DEVELOPMENT REVIEW COMMITTEE (DRC) COMMENT REPORT

PROJECT NAME: Modera 555

CASE NUMBER: R18060

REQUEST: Site Plan Level II Review: 350 Multifamily Residential Units in Downtown

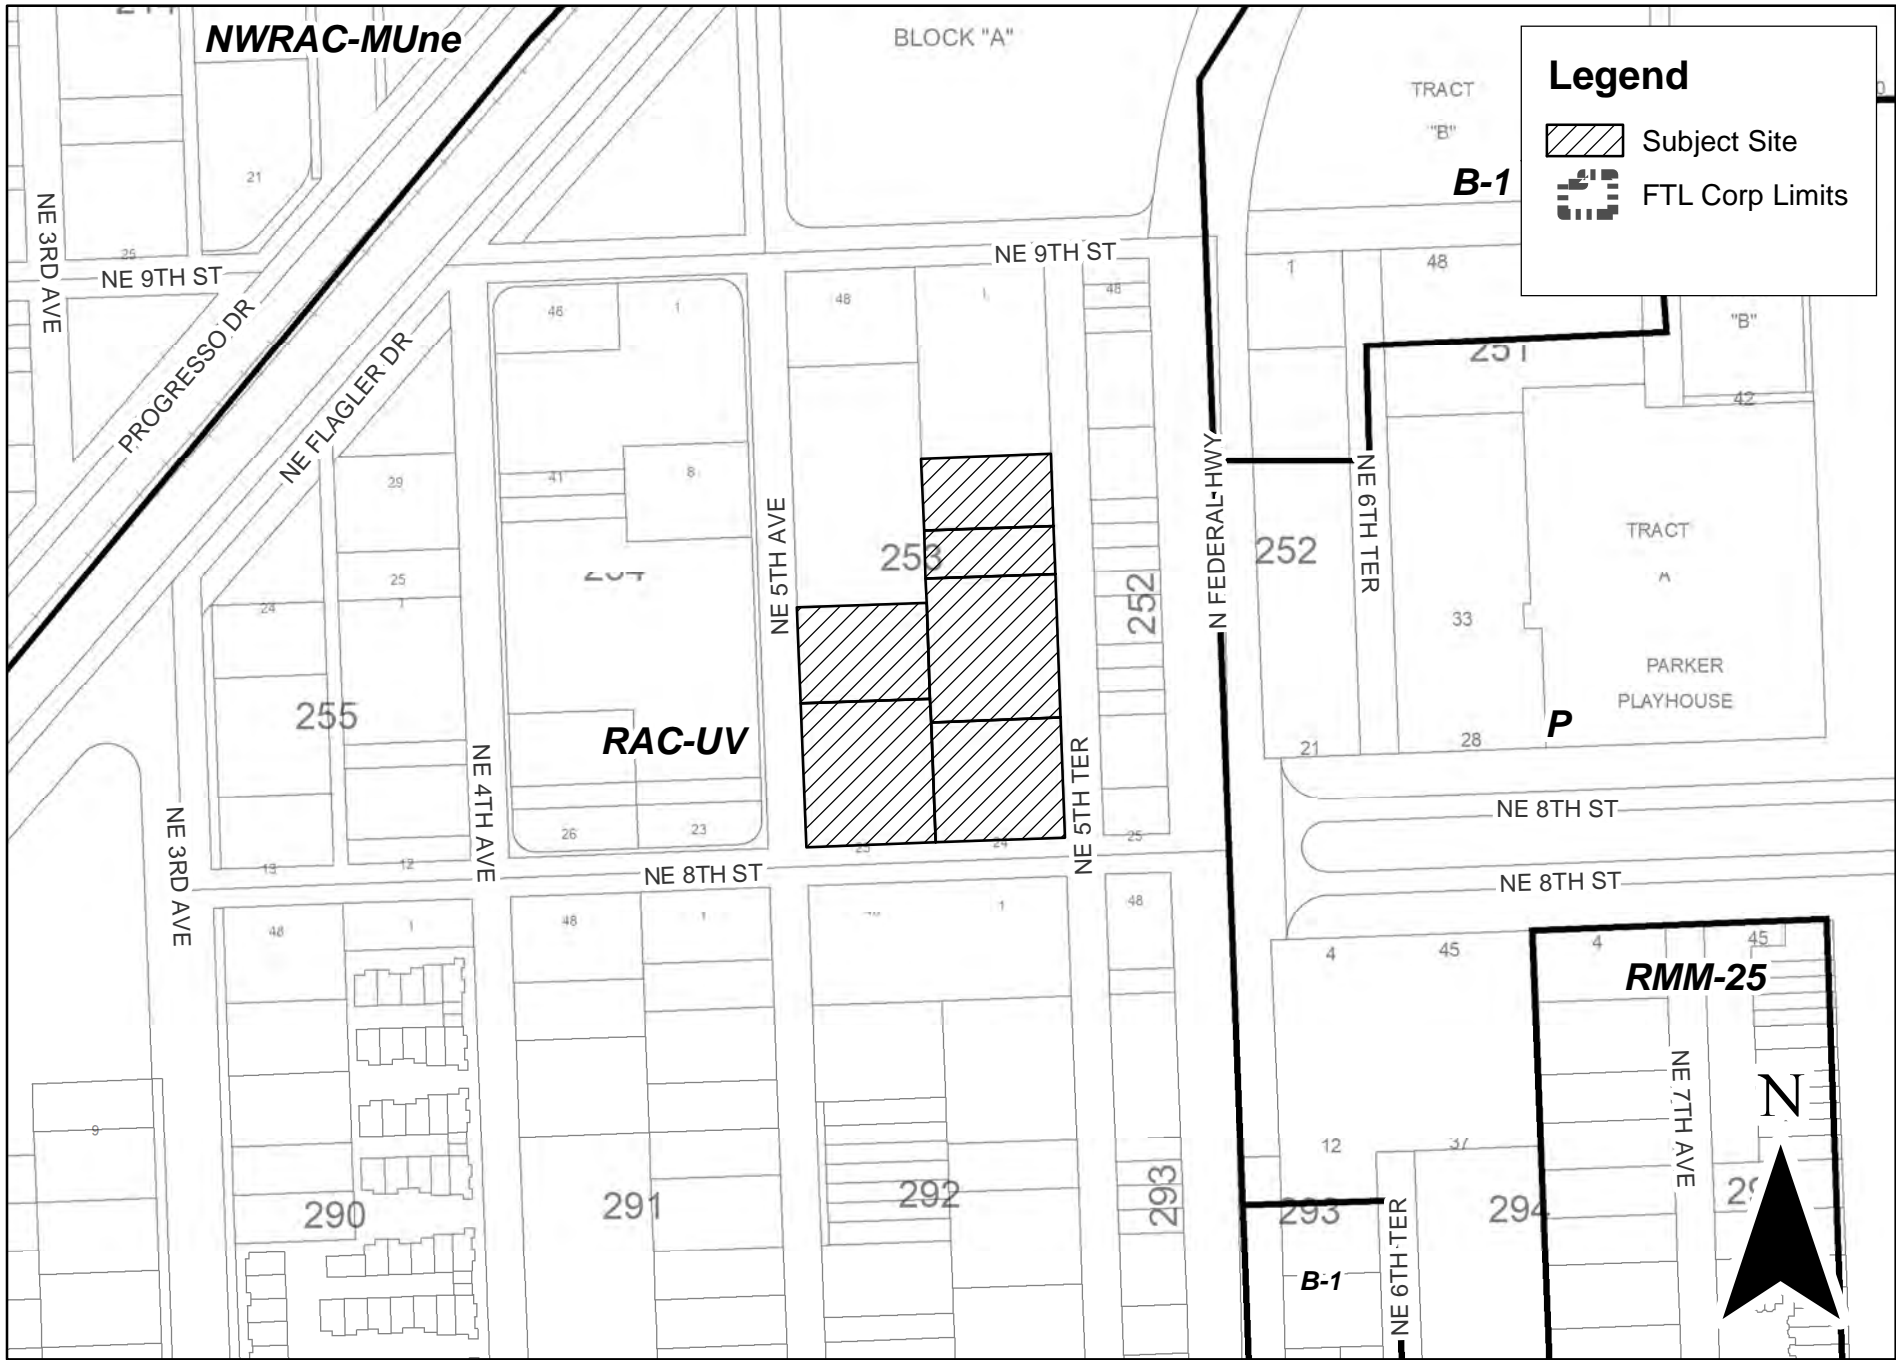
- 10) As per Downtown Master Plan, and in consideration of its highly-visible nature, the parking garage should be lined with habitable space especially in any highly visible location such as viewed from the north on US 1, Sears Town and the Sunrise Boulevard corridor. Please note that project design for this site should begin with a fully-lined parking garage or with appropriate screening material.
